P9
1881406
P7
1881406
U30
ISL21080DIH312Z-TK
U28 HIH-4000
U29 LM35_TO-92
TP7 TP10 TP14 TP15
R10 R11 R12 R13 R14 R15 R16 R17
U24 U25 U26 U27
AD8628ARZ-REEL7
J8:
USE PHOENIX
HEADER 1881464
CONNECTOR 1881341
TEST POINTS
5 VDC IN
J8
Phoenix
1881464
P8
1881341
R1 0 Ohms
D2
TVS_5V_Standoff
U1E U2E U3E U4E
SN74HC02NSR
MOUNTING HOLES # 6 WITH WASHER
MT1 MT2 MT4 MT3
RN2D
5k
UNUSED
NOR
A + B
Rev C:
Connector change
Deletion of extra wire ways
Rev D:
?
Rev E:
Added U4 SR latch
Added input protection resistors
Rev F:
Changed drivers from source to sink.
Changed current sense input to 500 mV/A.
Added 8 more output channels.
Scaling is 0.5 V / A
Board dimensions to be the same as Relay Board VEN2016-003. With the same mounting holes
Drawn by: P McGill, C Dawe, D Thompson and D French
Title
TTL-24Vdc Level Shift LCB
Size D
Document Number 100221371
Rev J
Date: Tuesday, March 01, 2022

Sheet 1 of 7

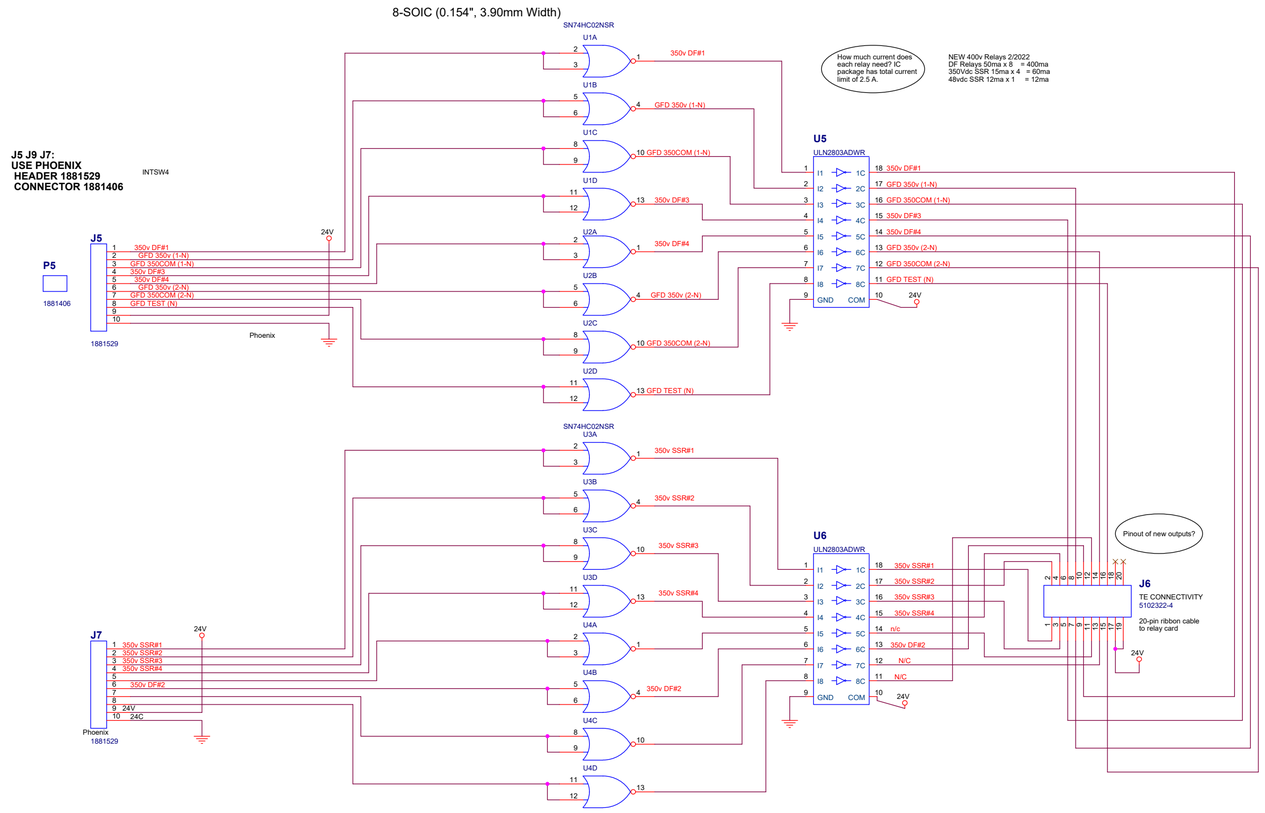
8-SOIC (0.154", 3.90mm Width)
SN74HC02NSR
How much current does each relay need? IC package has total current limit of 2.5 A.
NEW 400v Relays 2/2022
DF Relays 50ma x 8 = 400ma
350Vdc SSR 15ma x 4 = 60ma
48vdc SSR 12ma x 1 = 12ma
J5 J9 J7:
USE PHOENIX
HEADER 1881529
CONNECTOR 1881406
INTSW4
P5
1881406
J5
1881529
Phoenix
U5
ULN2803ADWR
U6
ULN2803ADWR
J7
Phoenix
1881529
Pinout of new outputs?
J6
TE CONNECTIVITY
5102322-4
20-pin ribbon cable to relay card
5102322-4
J6
CONNECT
J6 Pin 1 350v SSR#1
J6 Pin 2 350v SSR#2
J6 Pin 3 350v SSR#3
J6 Pin 4 350v SSR#4
J6 Pin 5 GFD 350COM (1-N)
J6 Pin 6 350v DF#3
J6 Pin 7 350v DF#4
J6 Pin 8 GFD 350v (1-N)
J6 Pin 9 350v DF#1
J6 Pin 10 350v DF#2
J6 Pin 11 N/C
J6 Pin 12 N/C
J6 Pin 13 N/C
J6 Pin 14 GFD 350v (2-N)
J6 Pin 15 GFD 350COM (2-N)
J6 Pin 16 GFD TEST (N)
J6 Pin 17 24v
J6 Pin 18 N/C
J6 Pin 19 24v
P6
1658621-4
TE CONNECTIVITY
J11
FROM CURRENT MONITOR BOARD
MOLEX_0705530005
J10
TO DENKOVI DAEnetIP4
MOLEX_571-826632-5
